TOLEDO - LUCAS COUNTY PLAN COMMISSIONS

REF: PUD25-0002

SUBJECT: Amendment to Planned Unit Development, Originally Granted by Ord. 150-25, for a New Library and Storage Building

SITE LANDSCAPE PLAN
MAJOR SITE PLAN REVIEW

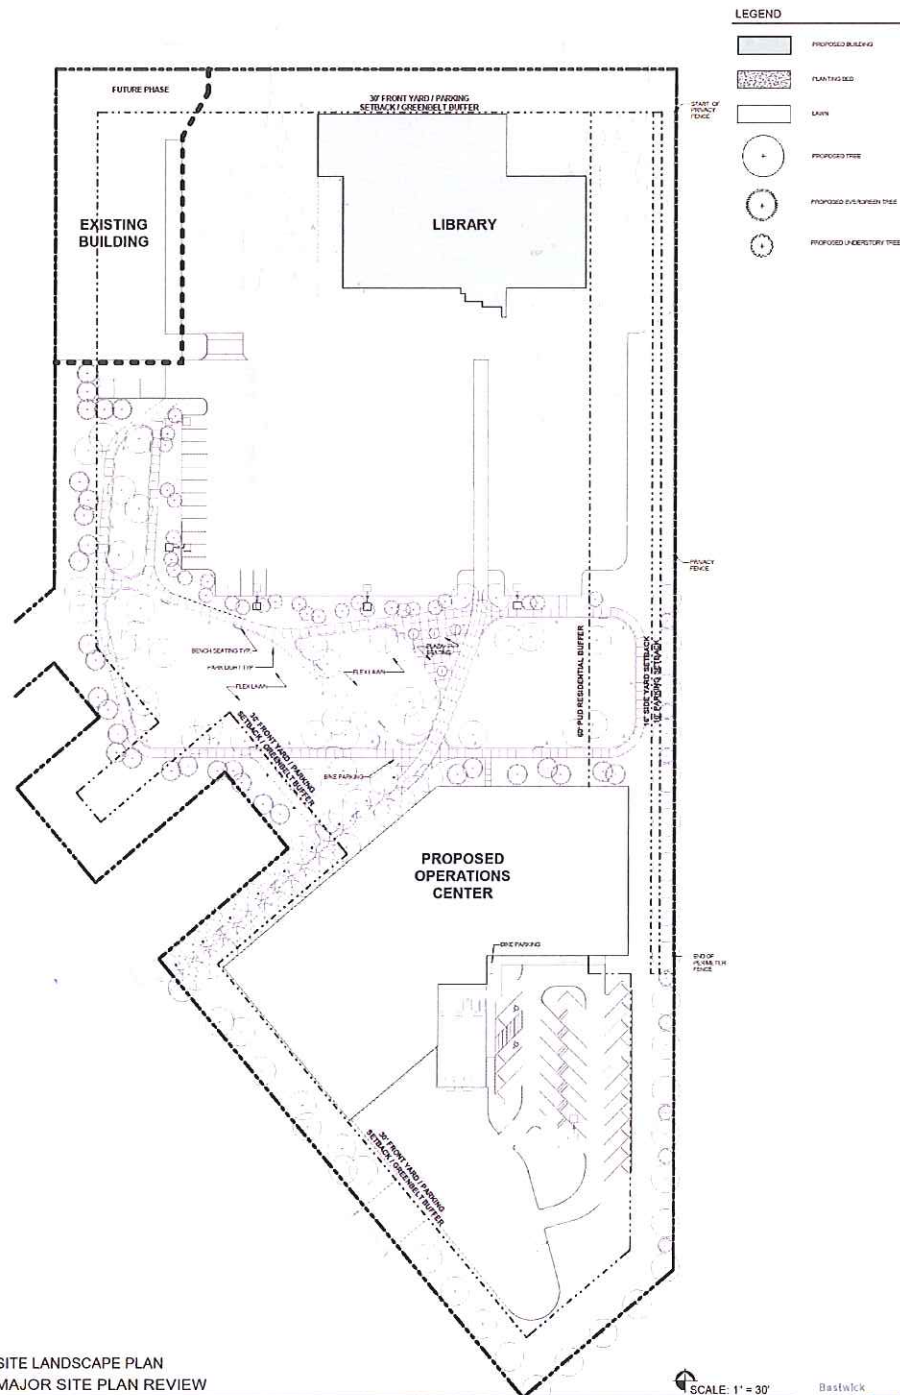
- a. Per TMC§1108.0202, a minimum thirty-foot-wide frontage greenbelt along public rights-of-way is required that contains at least one (1) tree for every thirty-feet (30') of frontage. Nineteen (19) trees are required along Tremainsville Road and the tree planting plan depicts fifteen (15). Additionally, the frontage greenbelt shall include a solid evergreen hedge, which is not provided. **Not acceptable as depicted. An additional four (4) trees and a solid evergreen hedge shall be provided.**

- b. Per TMC§1108.0203, a Type A Buffer is required along a portion of the east property line and a Type B Buffer is required along the other portion of the east property line. These two (2) buffers require a total nineteen (19) canopy trees and seventy-one (71) shrubs along the eastern property line. The tree planting plan depicts fifteen (15) canopy trees and eight (8) understory trees for an equivalent of twenty (20) canopy trees. The shrub planting plan also depicts twenty-five (25) shrubs. **Not acceptable as depicted. An additional forty-six (46) shrubs shall be provided.**

- c. Per TMC§1108.0204, two (2) canopy trees and six (6) shrubs are required to be installed in interior landscape areas in a parking lot for each ten (10) parking spaces. A total of six (6) trees and eighteen (18) shrubs are required in the interior of the parking lot based on the proposed thirty (30) parking spaces. There is no landscaping provided for the parking lot. **Not acceptable as depicted. The required six (6) trees and eighteen (18) shrubs shall be provided.**

- d. Perimeter landscaping must be installed along the parking lot area adjacent to a street, place or driveway, or which is visible from an adjacent property. The frontage greenbelt counts toward perimeter landscaping requirements along Tremainsville Road. The proposed trees in the Type B Buffer along the east property line count towards the perimeter landscaping requirements; however, a solid evergreen hedge is required along the parking area to shield headlights from adjacent properties. **Not acceptable as submitted. A continuous shrub hedge shall be provided along the east side of the parking lot.**

SITE SHRUB PLANTING PLAN
MAJOR SITE PLAN REVIEW

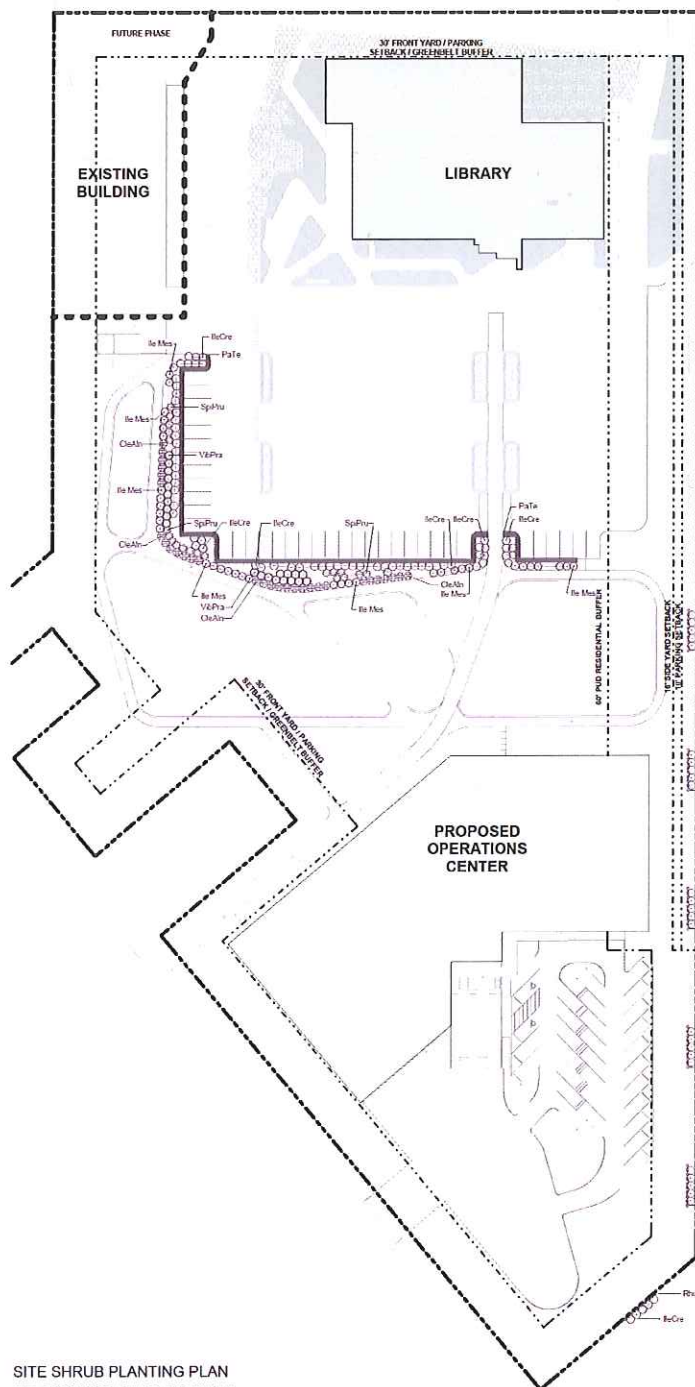
- g. Per TMC§1103.1209(A.3), grade level mechanical equipment shall be screened from adjoining residential parcels and from the right of way(s).
- h. Per TMC§1108.0204(B.6), landscaped areas may not contain bare soil, aggregated stone, or decorative rock. Any ground area must be covered with hardwood mulch, grass, or other vegetative ground coverage. The proposed rock mulch is not permitted.
